ECE/TRANS/WP.29/GRE/2008/52 11 July 2008

World Forum for Harmonization of Vehicle Regulations

Working Party on Lighting and Light-Signalling

<u>Proposal for Supplement 16 to the 02 series of amendments Regulation No. 7</u> (Front and rear position (side) lamps, stop lamps and end-outline marker lamps)

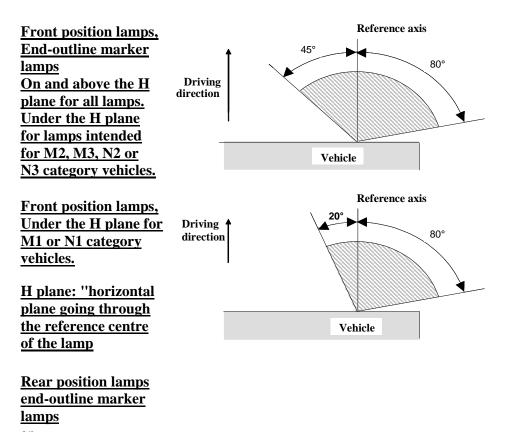
Annex 1, amend to read:

"Annex 1

FRONT AND REAR POSITION LAMPS, END-OUTLINE

(b) for category S3 or S4 stop lamp for which they are 10° above and 5° below the horizontal;

The current visibility requirements were written in the early 1970s. They were easily fulfilled in those times because the shapes of the vehicles were simple and rather boxy. In recent years, fuel-efficient aerodynamics and pedestrian protection have led to more contoured shapes making impossible the fulfillment of the 15° down and 45° inboard (15D-45inboard) visibility requirement of the front position lamp. This proposal tends to eliminate this requirement;

- (a) Reducing the interior visibility angle from 45° to 20° under the H plane has no impact on the distance of visibility of the vehicle observed by pedestrians or other road users along its longitudinal median plan;
- (b) In the case of a vehicle with 1400 mm between the reference axis of the front position lamps, this angular reduction, as seen by an observer squatting down on the median longitudinal plan of the vehicle, leads to a minimal change of the visibility distance of just 1.22 m:

With the current visibility angle, the lamp is visible at $D_1 = 1,400 \ge 0.5 \cot g 45^\circ = 700$ With the proposed visibility angle, the lamp is visible at $D_2 = 1,400 \ge 0.5 \cot g 20^\circ = 1,923$ The "danger" distance is increased by a modest

$D_2 - D_1 = 1,400 \times 0.5 (\cot 20^\circ - \cot 45^\circ) = 1,223 \text{ mm}$
